DRAFT SUMMARY OF FINDINGS

TO: John M. Gillam, Policy and Systems Planning Section Manager
Paul Smith, Transportation Planning Division Manager
Portland Bureau of Transportation

RE: **CRC Design Refinements Flexible Service Work Order #36670-1**
DRAFT Summary of Findings

CoP Refinement Option (10-lane permanent main span; bi-level)

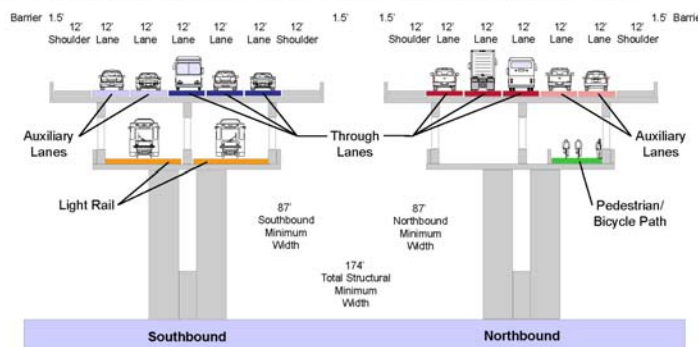
- One lane eliminated in both directions (thereby producing a 2-lane reduction) could be expected to produce an approximate \$50 million savings on the main and approach spans (10-lane span with standard width shoulders compared to a 12-lane span with standard shoulders)
- A cost comparison between a 12-lane span with narrow shoulders (CRC LPA Full Build) and a 10-lane span with standard width shoulders (12’) would show a lower cost savings than the figure mentioned above. This is because a full 24’ narrowing (corresponding to the \$50 million cost savings figure) would not be realized despite the elimination of two 12’ lanes (one in each direction). Widening each of the 4 shoulders to 12’ would add back 16’ of bridge width.
- Further costs would likely be saved elsewhere in the bridge influence area closest to the main span (e.g., southbound lane reduction across Hayden Island)

CRC LPA Phase I
10-Lane Main Span

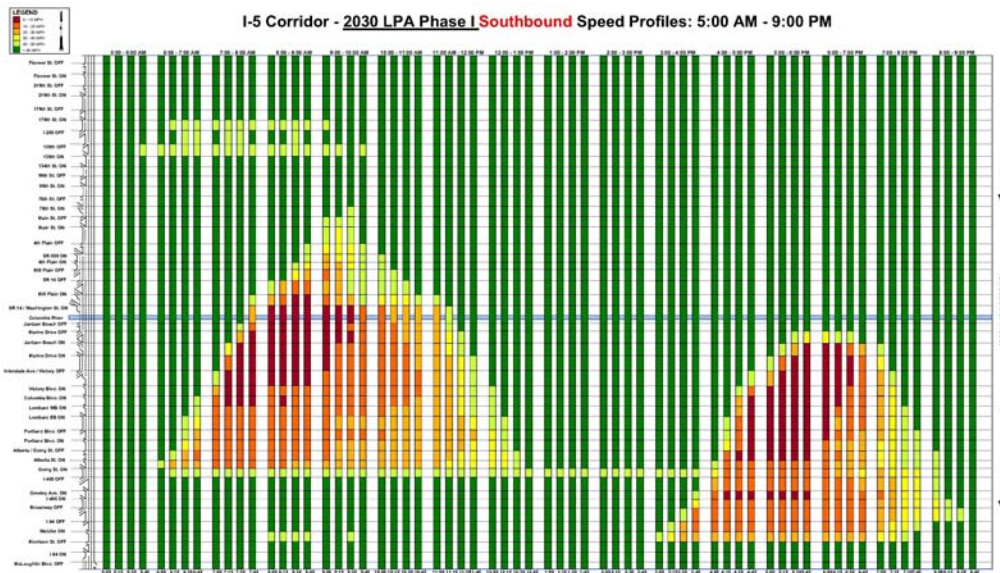
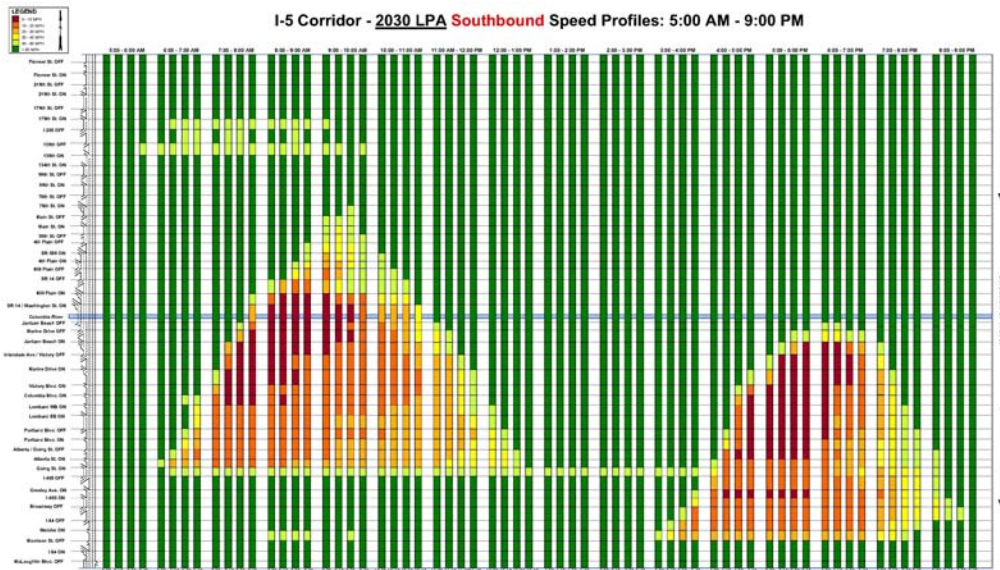
- Backups on I-5 south of the CRC project area will negatively affect I-5 A.M. peak southbound performance in the CRC project area in 2030 (CRC VISSIM speed profile analysis shows speeds of less than 20 mph in the project area); this backup condition also masks, in the speed profile diagrams, the performance of the 10- and 12- lane bridges in the project area.
- There are no appreciable differences visible in the speed profiles between the CRC 12-lane proposal and the 10-lane proposal; both show significant improvements over the performance of the No-Build alternative.
